Access Compliance Report

Public Rights-of-Way

(Curb Ramps)

Intersection ID: 48555	Main Street: COTTON_PRESS_RD	Cross Street: RIDGEFOREST_DR	Location: NW
ADA ID: BAA381235156	Ramp Type: Combination1Diag	Initial Pass/Fail: Fail	Overall Compliance: No
Codes/Mitigation Info/Possible Solution		Field Measurements/Component Compliance	
Severity Score: 0

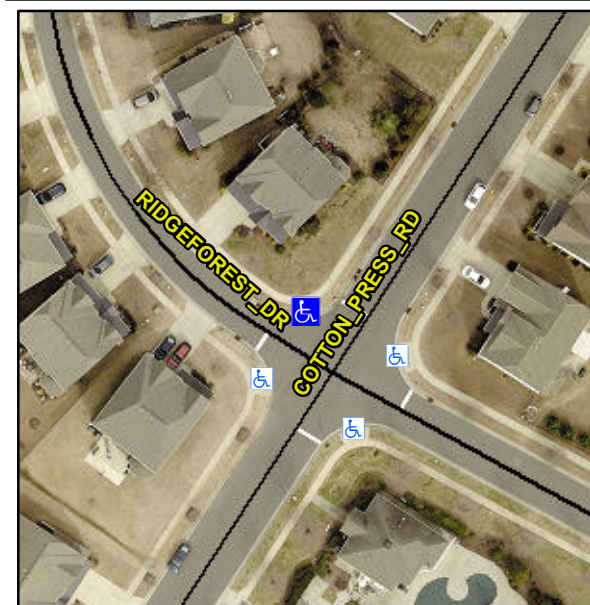
Surveyor Notes:

RT RP < 5%

PROW/ADA:

Not Found, R304.5.1, R304.5.1, R304.2.2, R304.5.3

Compliance	Description	Data	Compliance	Description	Data
N/A	Ramp Length LT (in)	47.0	N/A	Ramp Length RT (in)	46.0
No	Ramp Width LT (in)	47.0	No	Ramp Width RT (in)	45.0
Yes	Ramp Slope LT (%)	5.7	Yes	Ramp Slope RT (%)	3.1
No	Ramp XSlope LT (%)	2.6	Yes	Ramp XSlope RT (%)	1.5
N/A	Ramp Length (in)	72.0	No	Ramp Slope (%)	9.0
No	Ramp Width (in)	46.0	No	Ramp XSlope (%)	3.5
N/A	Flare Type LT	N/A	N/A	Flare Type RT	N/A
N/A	Flare Slope LT (%)	N/A	N/A	Flare Slope RT (%)	N/A
N/A	Flare Traversable LT?	N/A	N/A	Flare Traversable RT?	N/A
N/A	Landing Length (in)	N/A	N/A	DWS Provided?	N/A
N/A	Landing Width (in)	N/A	N/A	DWS Contrast?	N/A
N/A	Landing Slope (%)	N/A	N/A	DWS Length (in)	N/A
N/A	Landing X Slope (%)	N/A	N/A	DWS Full Width?	N/A
N/A	Landing Curb? (Y/N)	N/A	N/A	DWS Offset (in)	N/A
N/A	Shared Landing?	N/A			
N/A	Gutter Ponding?	N/A	N/A	Gutter Slope (%)	N/A
N/A	Gutter Lip Ht (in)	N/A	N/A	Gutter X Slope (%)	N/A
N/A	Painted X Walk1?	No	N/A	Painted X Walk2?	No

Possible Solutions:

Remove & Replace Curb Ramp With Two New Directional Ramps or Equivalent.
